The Secretary
NSW Department of Planning, Industry and Environment

I refer to the Department's letter of 1 September 2020 regarding the notice of exhibition of the Environmental Impact Statement (EIS) for State Significant Development SSD-8184 for the Fairfield Sustainable Resource Centre Expansion located at the corner of Hassall Street and Widemere Road, Wetherill Park (Lot 1 DP 515773, Lot 34 DP 657040, Lots 35 & 37 DP 3082, Lot 100 DP 1220637, Lots 1 & 2 DP 620755, Lot 1 DP 368374) in the Fairfield local government area. Submissions need to be made to the Department by 2 October 2020.

Please find attached a copy of Endeavour Energy's submission made to Fairfield City Council on 21 May 2019 regarding Development Application No. 165.1/2019 at 2 Widemere Road WETHERILL PARK (PART LOT: 1 DP: 515773) for 'Proposed Community Recycling Centre'. The recommendations and comments provided therein are also applicable to this Development Application.

Figure 1 Extract from Architectural Site Plan prepared by 4d Architects – refer Appendix 5

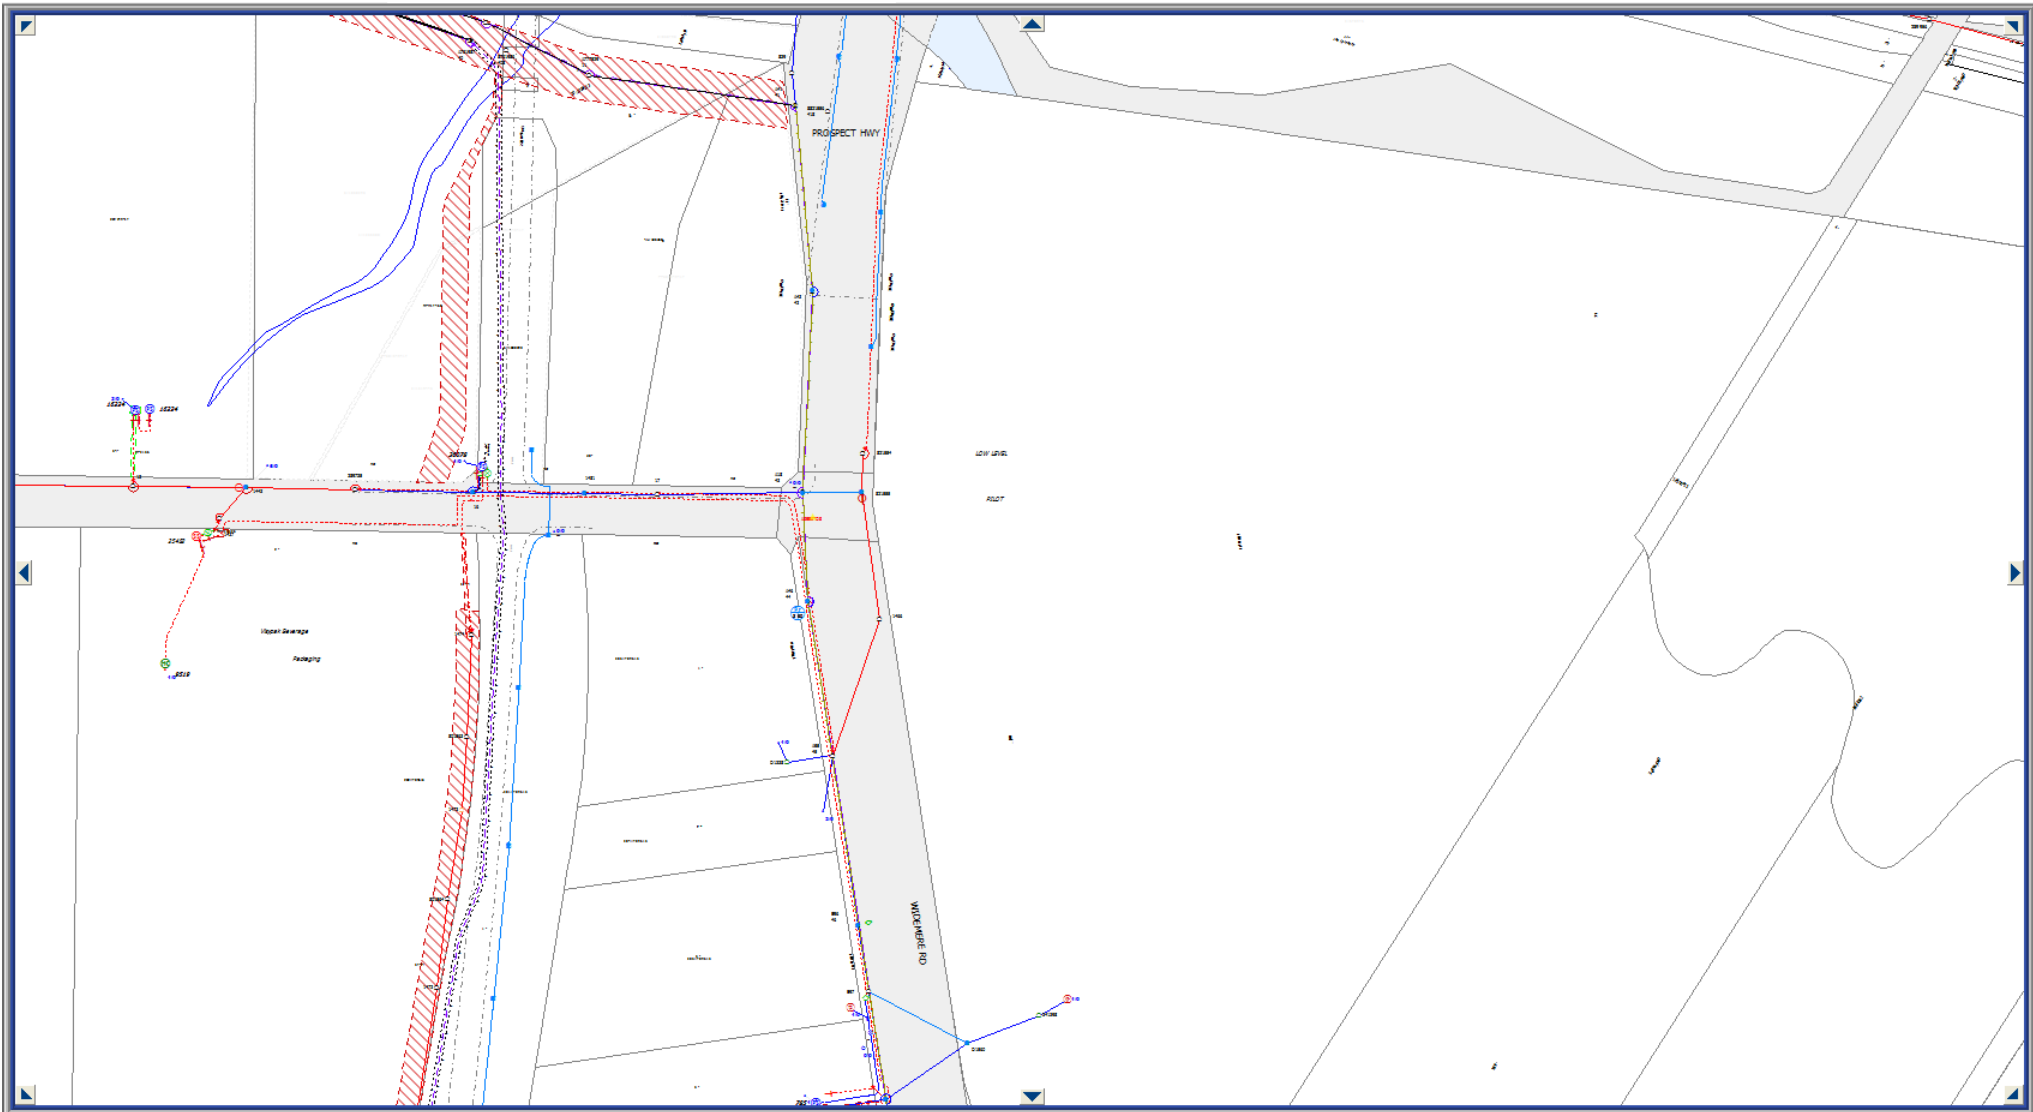
In regard to the Fairfield Sustainable Resource Centre, as shown in the below site plans from Endeavour Energy's G/Net master facility model (and extracts from Google Maps Street View) there are:

- Low voltage and 11,000 volt / 11 kilovolt (kV) high voltage overhead power lines and underground cables to the northern section of the Widemere Road road verge / roadway.
- Extended low voltage overhead power lines coming from a pole on the opposite side of Widemere Road to two customer owned / private poles (indicated by the green circles) providing a customer connection point for the existing facilities.
- Endeavour Energy's Wetherill Park Zone Substation is located approximately 440 metres to the south west at Redfern Street Wetherill Park (Lot 3 DP 584227).
